Model: PR-C101 No. : ECN20T023KGC-00

Date: 2020.6.12 Ref.: 20-05-0041

Subject: Change of printer controller firmware/ Countermeasure for EOL of ink

ribbon

Fig1

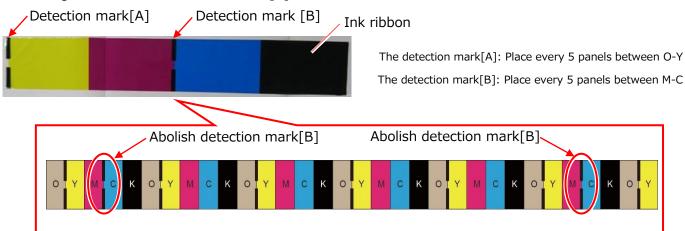
1-2. Change: Abolish the detection mark [B] between M-C.

No.	Item	Detail
1	Countermeasure for EOL of ink ribbon	Due to abolishing the detection mark [B] of the ink ribbon, it is changed to "detection mark [B] detection sequence". This makes it possible to compatible with the old and new ink ribbons.

Fig2

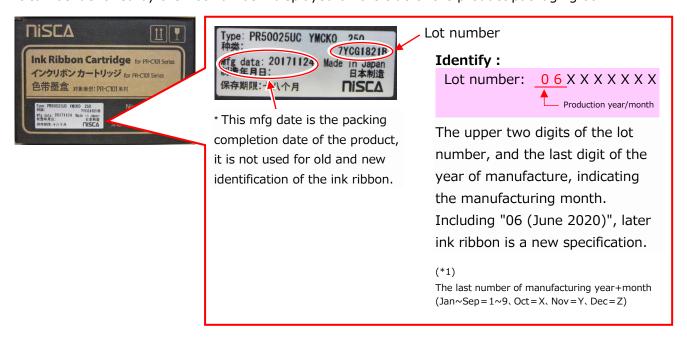
It can be identified by the "lot number" displayed on the side of the product packaging box.
